Questions & answers

regarding the new wedi channel drains and other
changes to wedi linear drainage for 2017

FAQs new wedi drain technology

2017 channel drains – visible changes

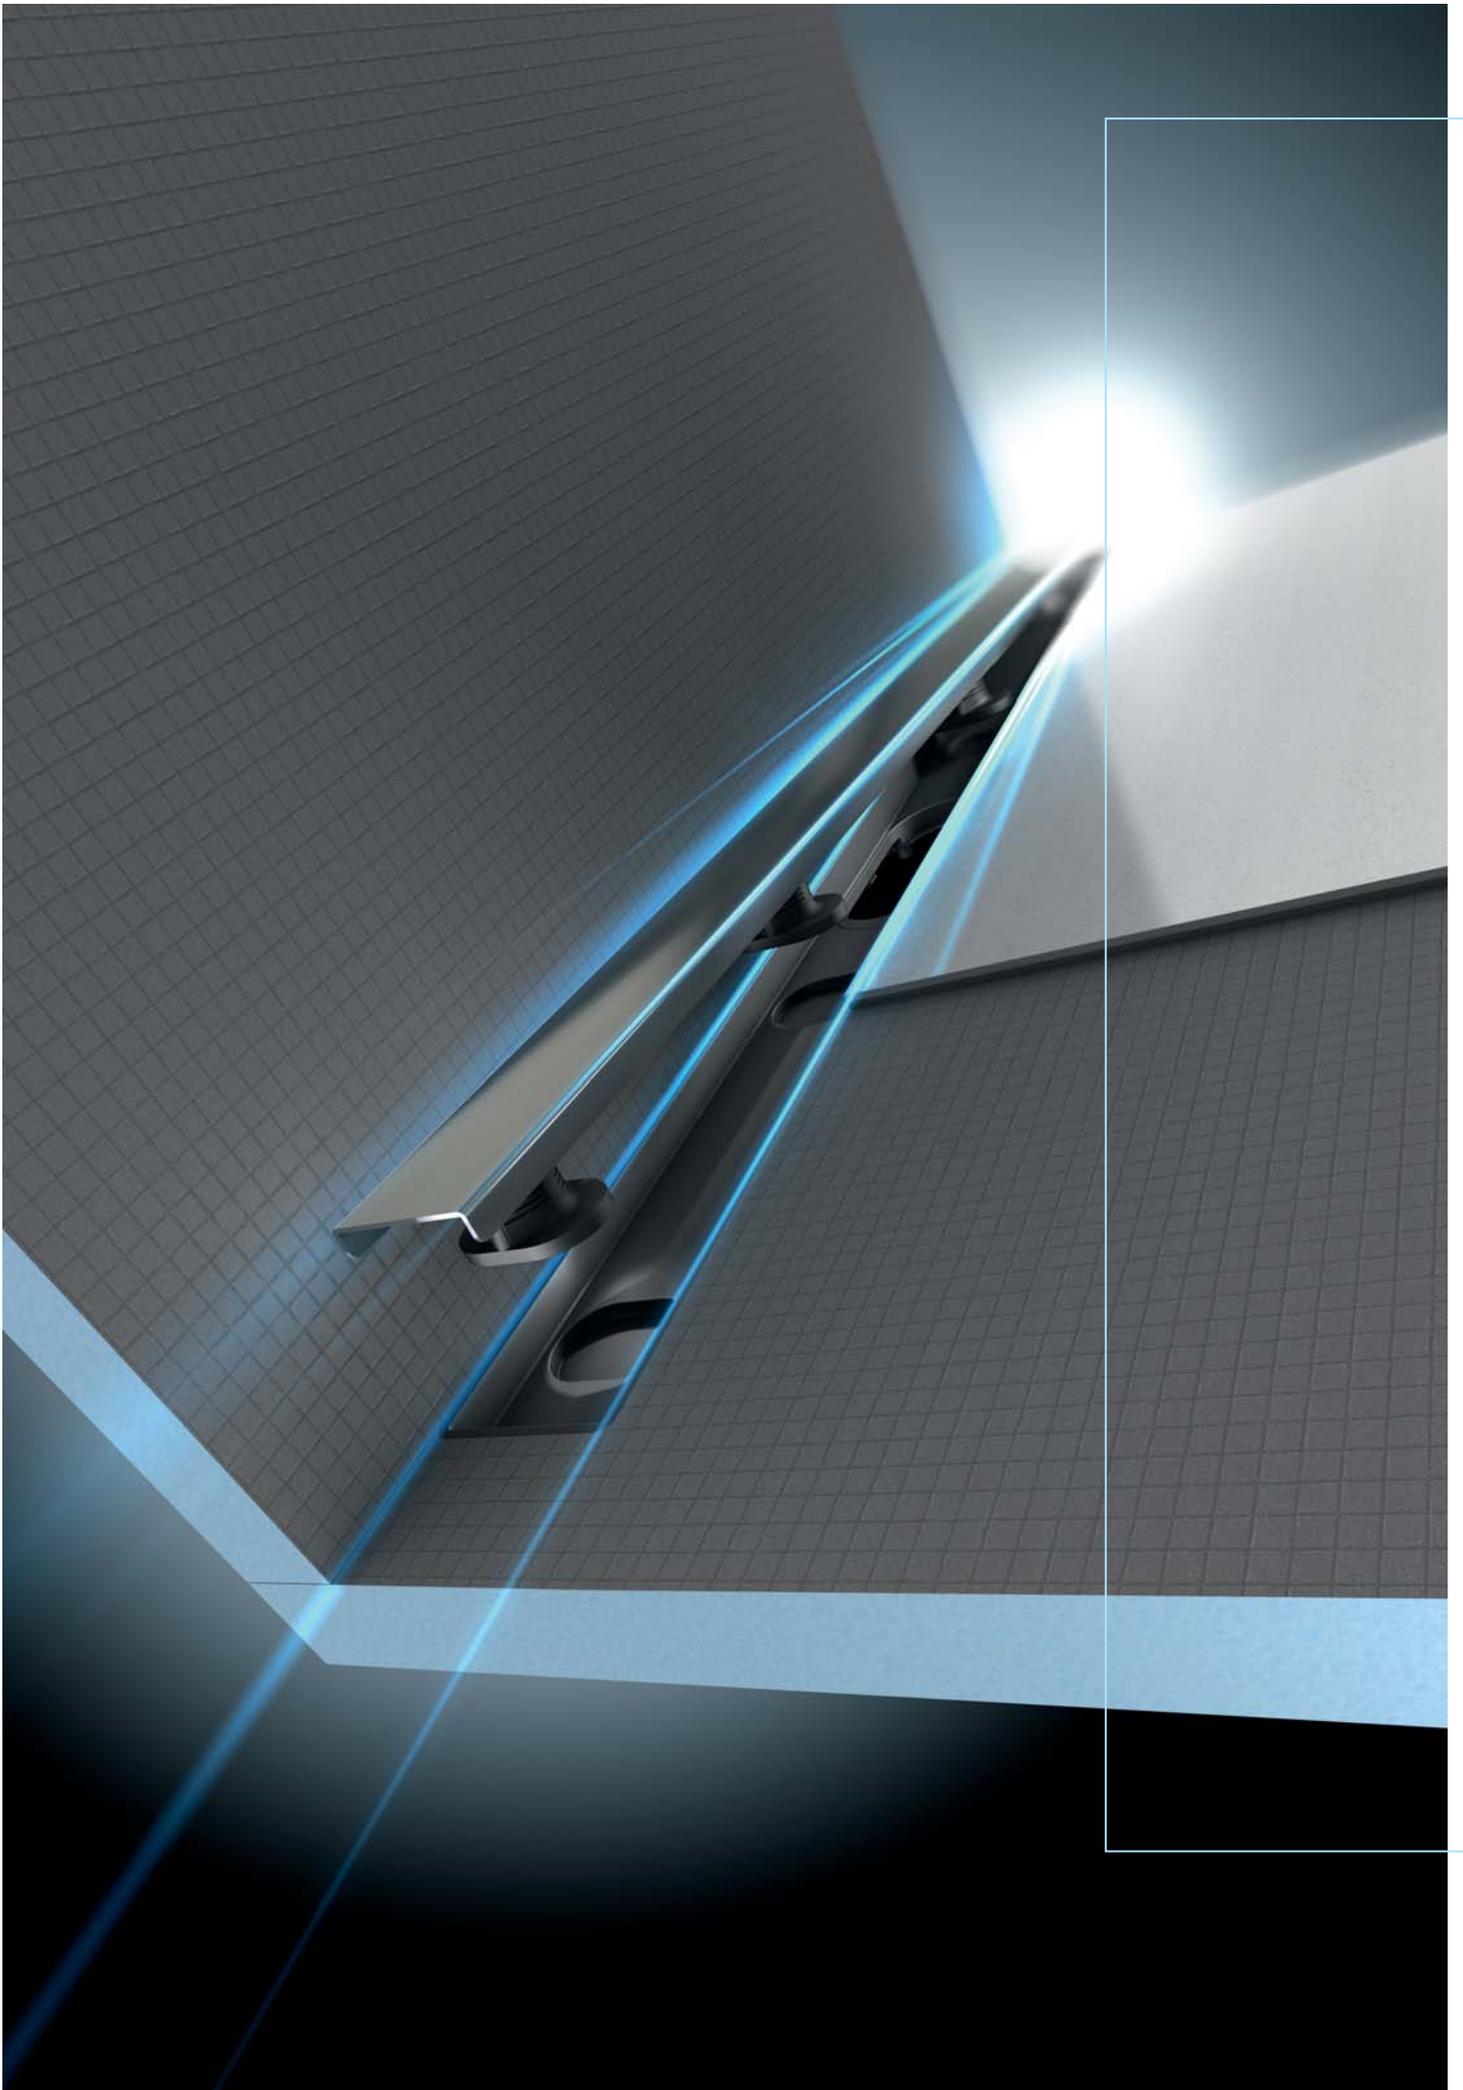
Why is there no longer a ball joint in the 2017 horizontal channel drain?

Why do the drains no longer have a wraparound edge?

Why does the lip seal now sit directly in the drain housing?

The connection piece already has a preformed gradient of 1.5 % and the drain bowl can be conveniently freely positioned through 360°. Optimal connection convenience is thus ensured.

The broad edge would interfere with the close-to-wall model of the Riolito neo and would no longer have any additional benefits for the wedi system.

It offers convenient installation and, in the new model, matches the tried and tested principle of a plug-in sleeve seal in domestic piping construction better (the connecting piece is pushed into the seal, not the seal into the connection piece).
